Project No. 2021\_154

MIDLOTHIAN ISD STADIUM ADDITIONS AND RENOVATIONS

ADDENDUM NO. 2

DATE: October 18, 2021

1 FOUNDATION PLAN ALTERNATE #6  
SCALE : 1/8" = 1'-0"

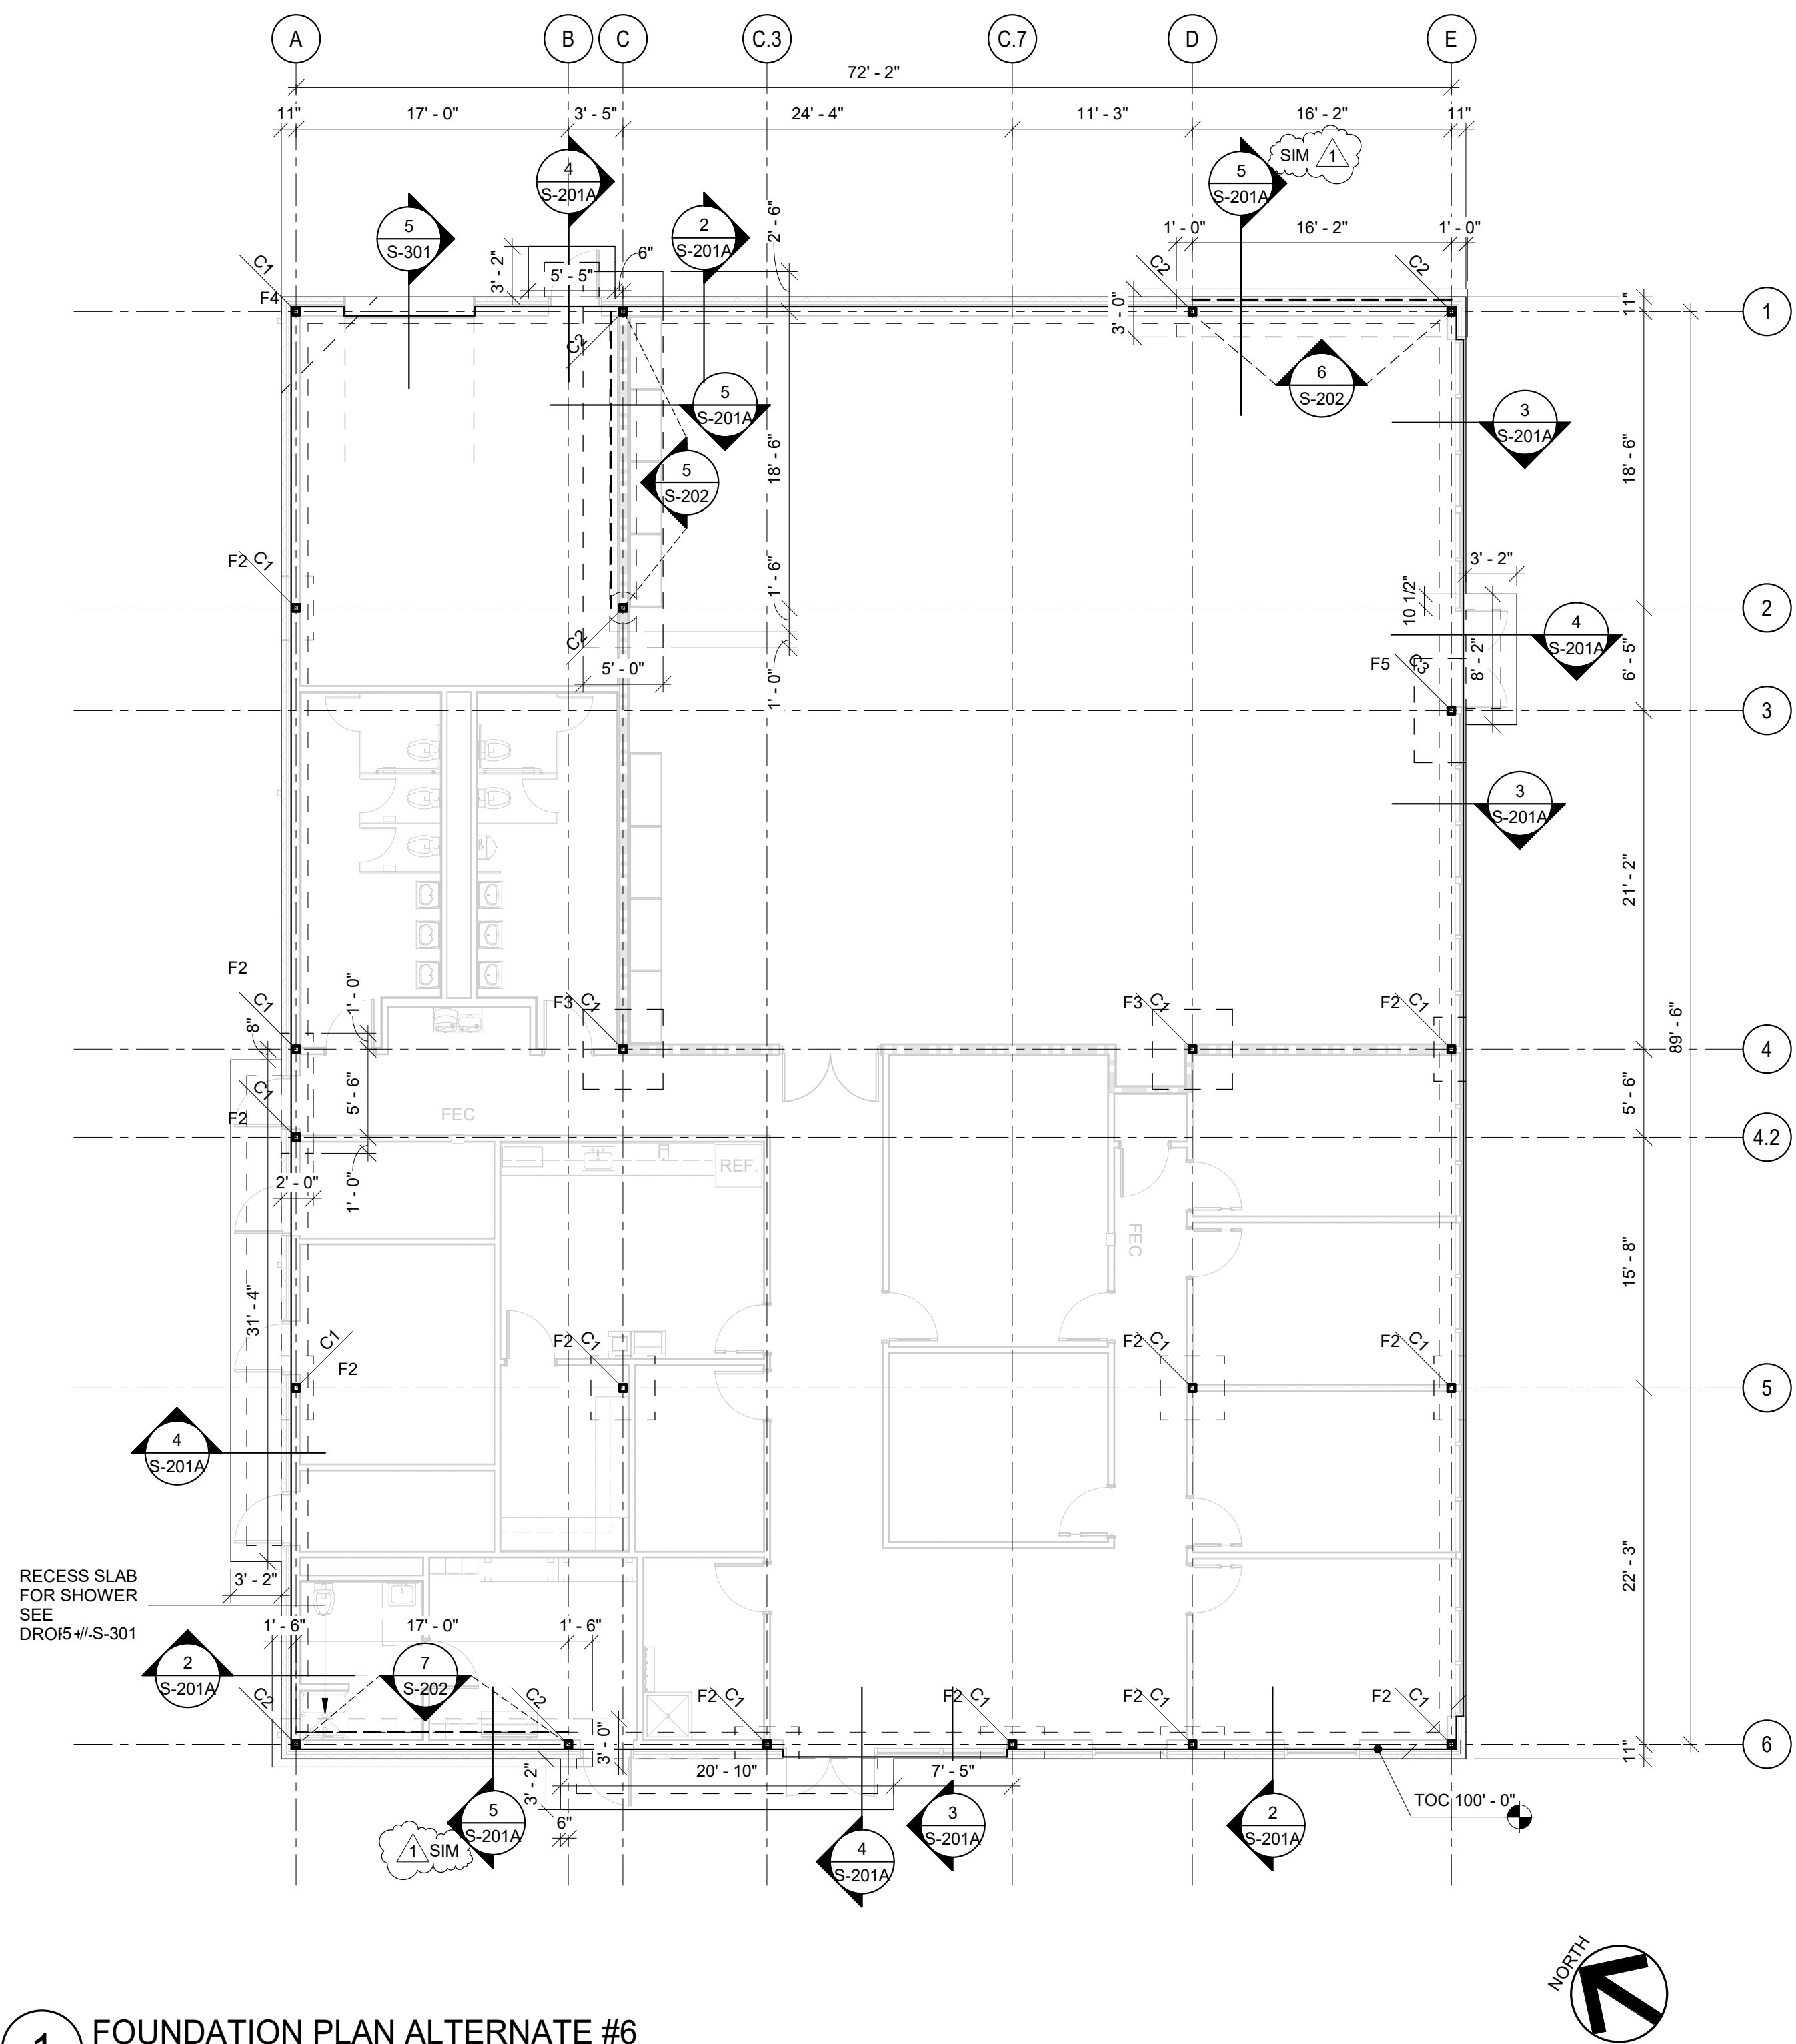
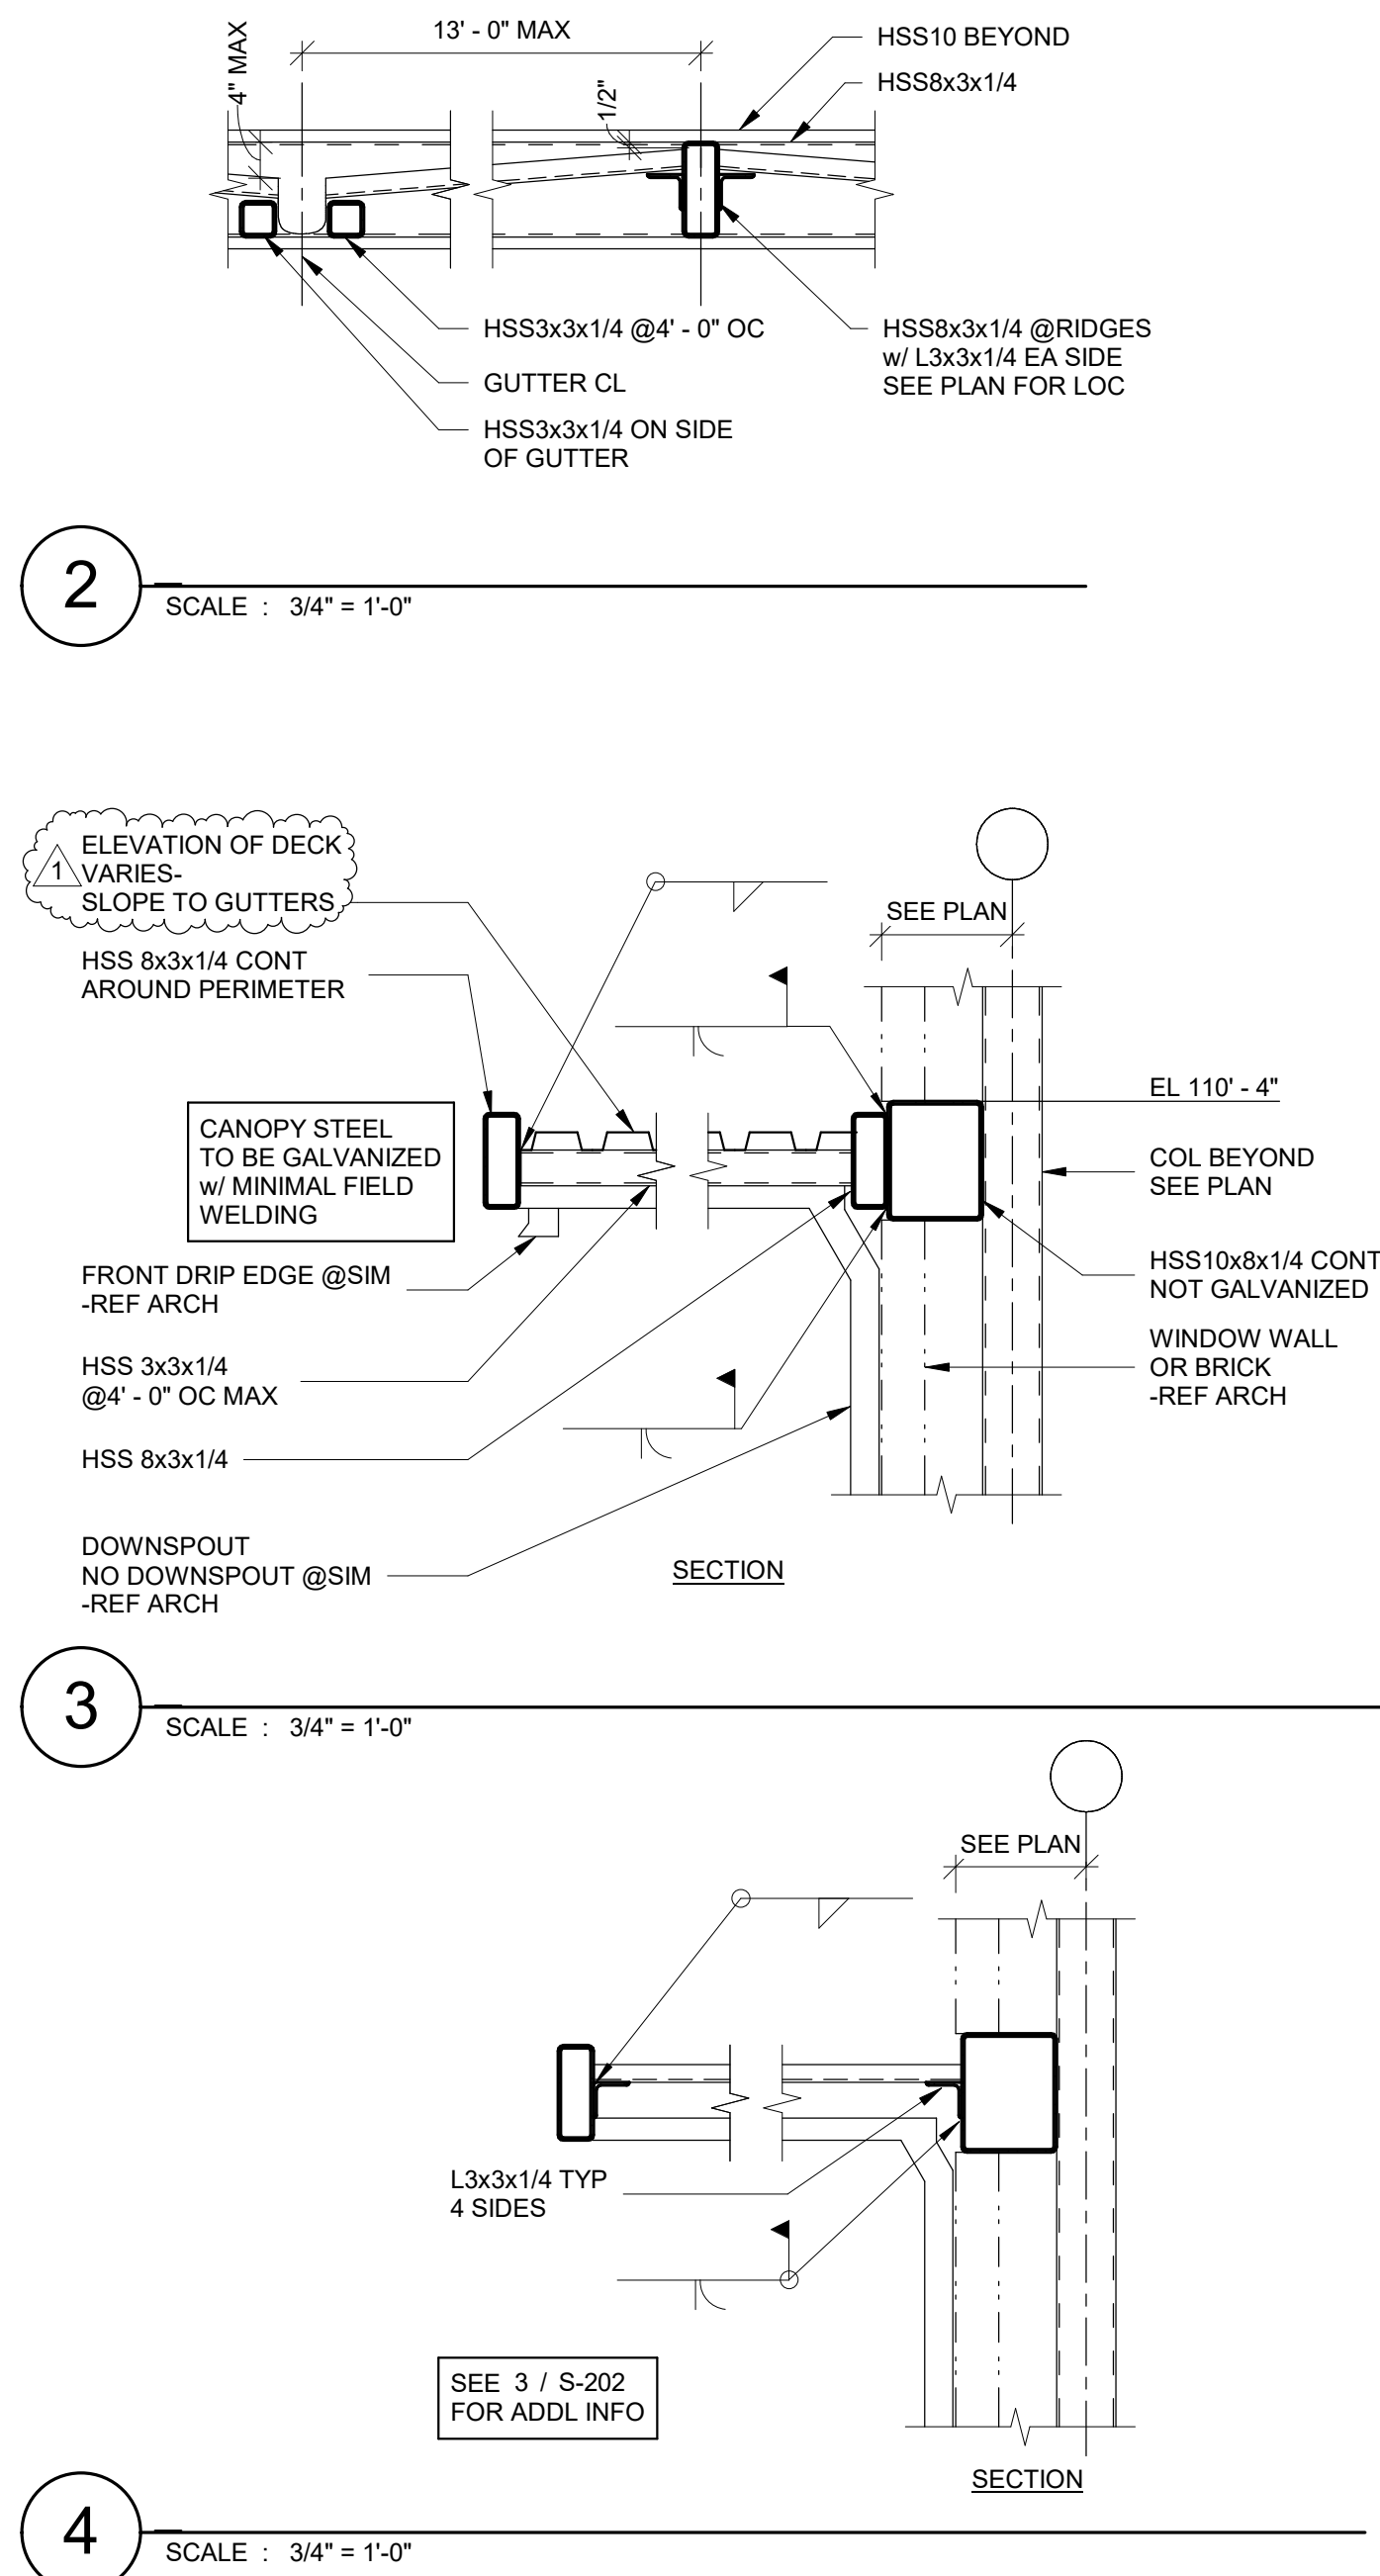
- a. 1/ S-201A Detail Reference UPDATED
- b. 4/ S-201A Compressible filler at building REMOVED
- c. 7/ S-201A UPDATED Reinforcement, Fixed graphics
- d. Footing Schedule Reinforcement UPDATED
